**TECHNICAL BULLETIN**  
**Bell Helicopter** **TEXTRON**

No. 214ST-02-167

**MODEL AFFECTED:** 214ST

**SUBJECT:** TAILBOOM STATION (BS) 293.50 BULKHEAD INSTALLATION AND VERTICAL FIN ASSEMBLY SPLICES, ADDITIONAL MAINTENANCE MANUAL INSPECTION REQUIREMENTS.

FIGURE 1

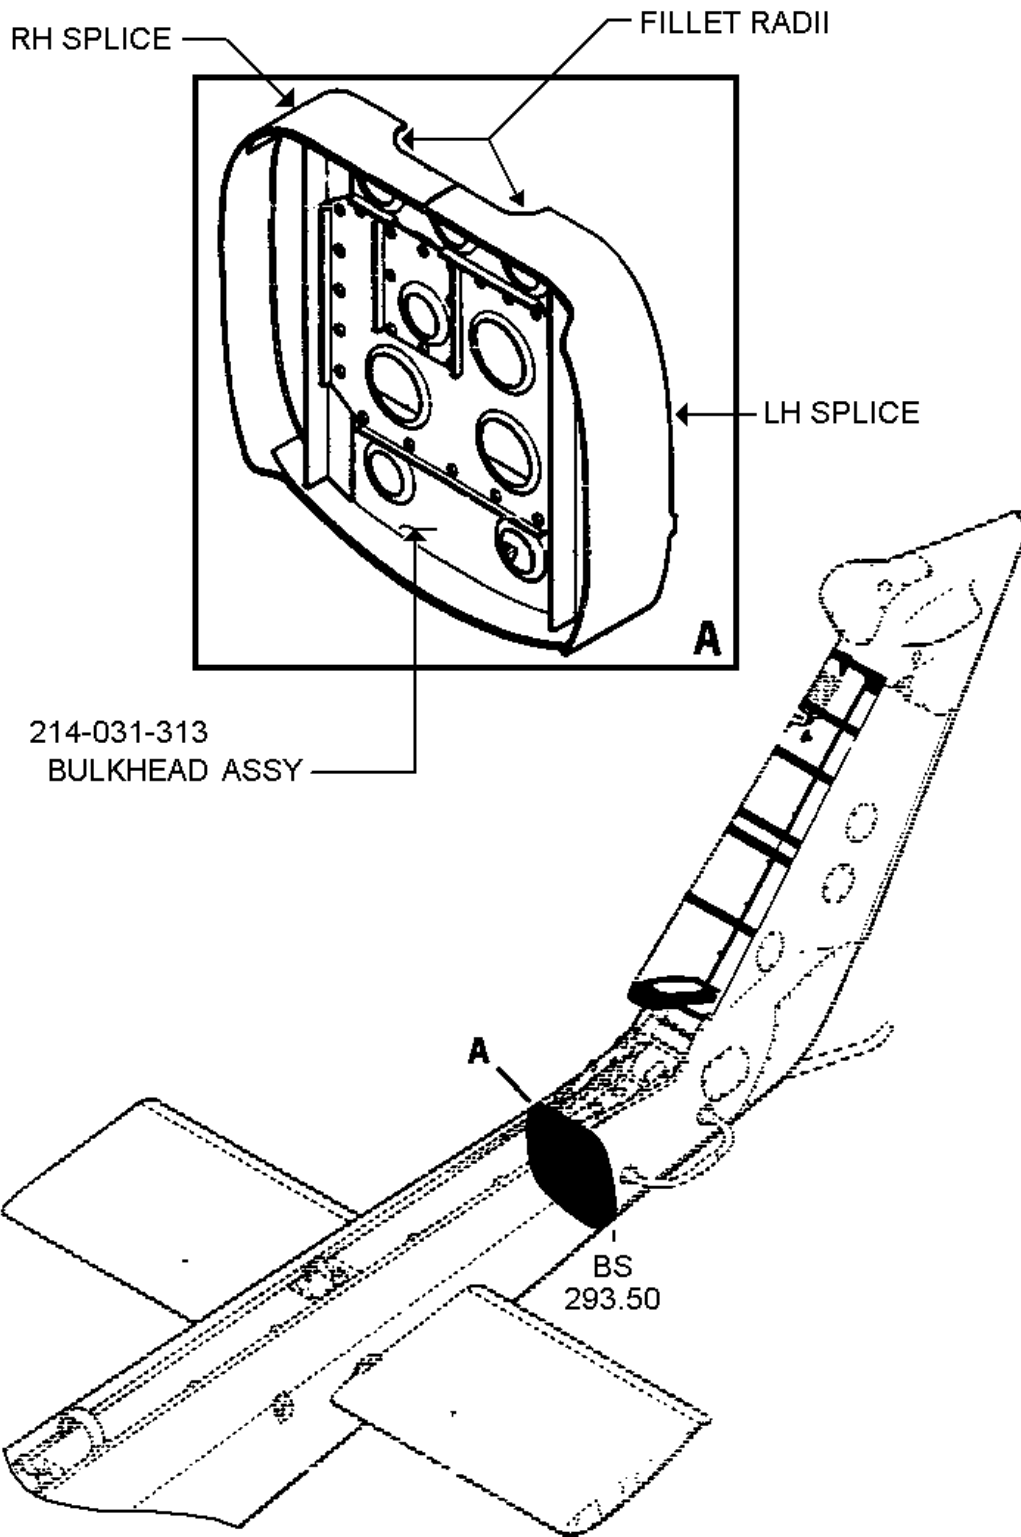
- 1A. Visually inspect BS 293.50 bulkhead assembly and attaching structure (including all visible portions of the bulkhead, its flanges, caps, and the P/N 214-031-313 splices) for cracks and working fasteners. Pay particular attention to the splices at the fillet radii, the attach fasteners, and the areas between the attach fasteners.
